Amendments to the Drawings:

REMARKS

FIG.2

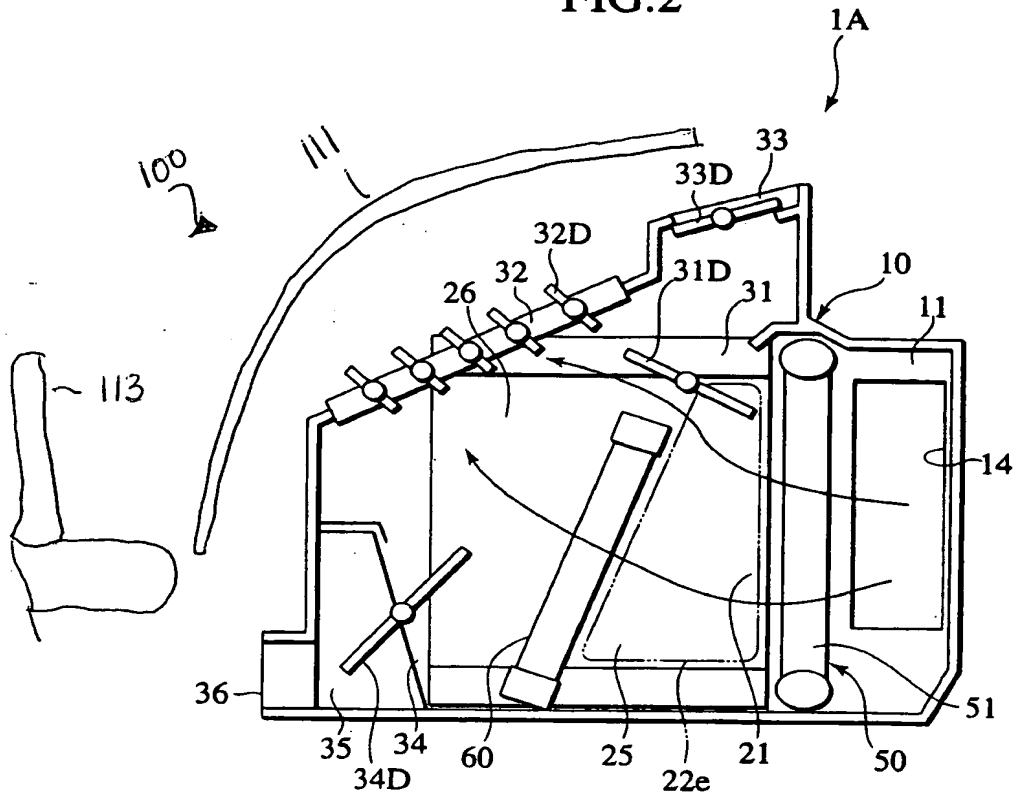
Figures 2 and 3 have been amended to show the air conditioning unit being arranged at a widthwise center of the vehicle 100 in the instrument panel 111 in front of a front seat 113 of the vehicle. Support for the amendments to the drawings can at least be found on page 6, lines 9-14 of the present specification. Thus, no new matter has been added.
